ADDENDUM No. Three (3) IFB No. 2019-032

#### CONSTRUCTION, RELOCATION OF COLLIN COUNTY TAX OFFICE, 900 E. PARK, PLANO

DATE: FEBRUARY 6, 2019

**A5**

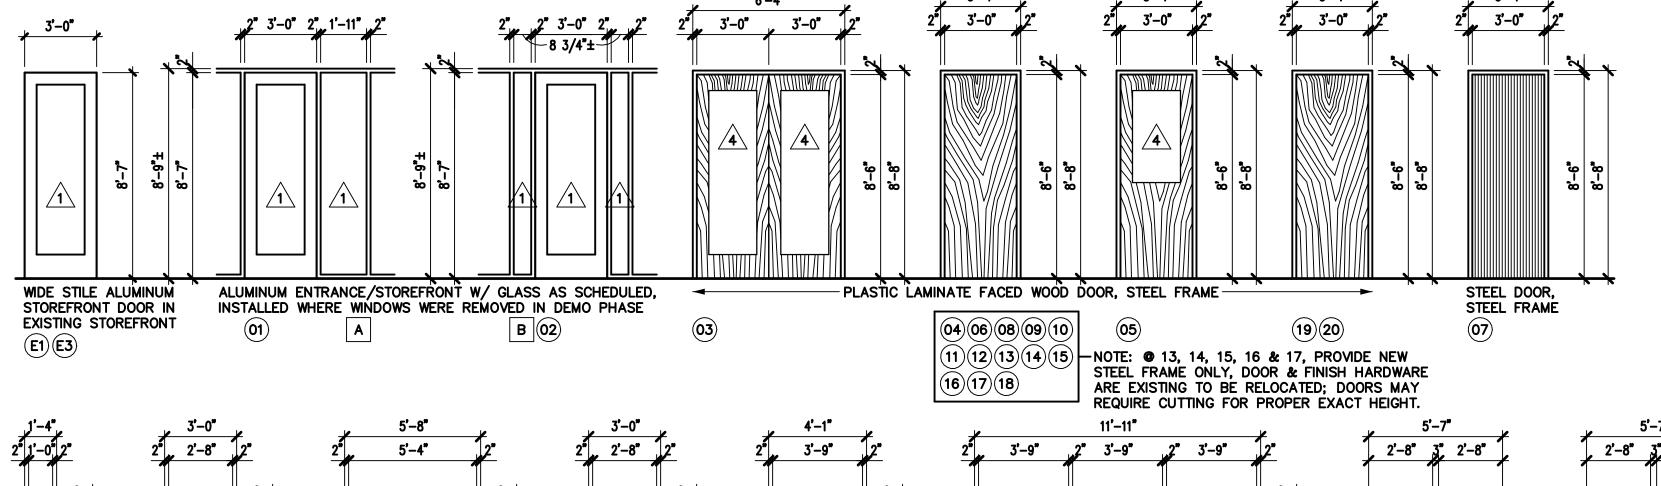
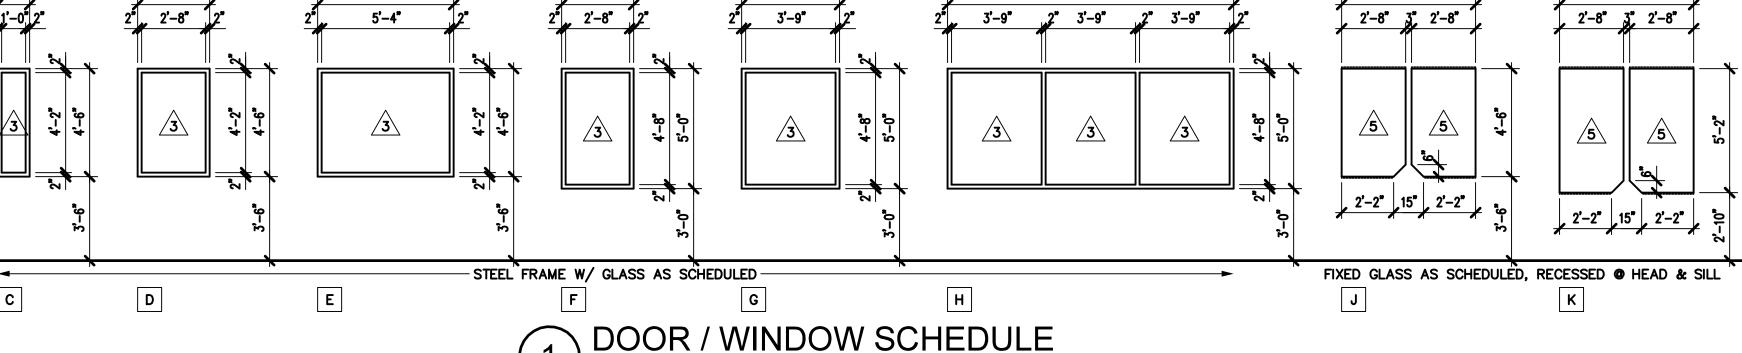
{NOTE 3: PROVIDE CERAMIC WALL TILE (CT-1) APPROX. 4 FEET HIGH ON 2'-6" EAST WALL & 5'-10" SOUTH WALL REV 2/1/19 ADJACENT TO MOP SINK.
